Access Compliance Report

Public Rights-of-Way

(Curb Ramps)

Intersection ID: 3954	Main Street: MOUNTAIN_COVE_DR	Cross Street: OVERLOOK_COVE_RD	Location: SE
ADA ID: D9D9C08A57F4	Ramp Type: Perp	Initial Pass/Fail: Fail	Overall Compliance: No
Severity Score: 46.25			
Codes/Mitigation Info/Possible Solution		Field Measurements/Component Compliance

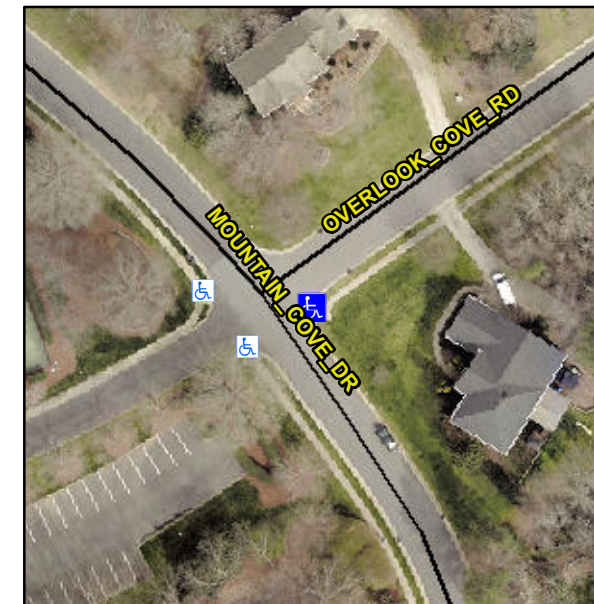
R304.5.1, R304.2.2, R304.5.3

Compliance	Description	Data	Compliance	Description	Data
N/A	Ramp Length (in)	97.0	No	Ramp Slope (%)	8.5
No	Ramp Width (in)	38.0	No	Ramp XSlope (%)	12.4
N/A	Flare Type LT	N/A	N/A	Flare Type RT	N/A
N/A	Flare Slope LT (%)	N/A	N/A	Flare Slope RT (%)	N/A
N/A	Flare Traversable LT?	N/A	N/A	Flare Traversable RT?	N/A
N/A	Landing Length (in)	N/A	N/A	DWS Provided?	N/A
N/A	Landing Width (in)	N/A	N/A	DWS Contrast?	N/A
N/A	Landing Slope (%)	N/A	N/A	DWS Length (in)	N/A
N/A	Landing X Slope (%)	N/A	N/A	DWS Full Width?	N/A
N/A	Landing Curb? (Y/N)	N/A	N/A	DWS Offset (in)	N/A
N/A	Shared Landing?	N/A			
N/A	Gutter Ponding?	N/A	N/A	Gutter Slope (%)	N/A
N/A	Gutter Lip Ht (in)	N/A	N/A	Gutter X Slope (%)	N/A
N/A	Painted X Walk1?	No	N/A	Painted X Walk2?	N/A
	X Walk 1 Direction	To SW		X Walk 2 Direction	N/A
N/A	X Walk 1 Width (in)	N/A	N/A	X Walk 2 Width (in)	N/A
	X Walk 1 Slope (%)	0.5		X Walk 2 Slope (%)	N/A
	X Walk 1 X Slope (%)	6.8		X Walk 2 X Slope (%)	N/A

Remove & Replace Entire Ramp.
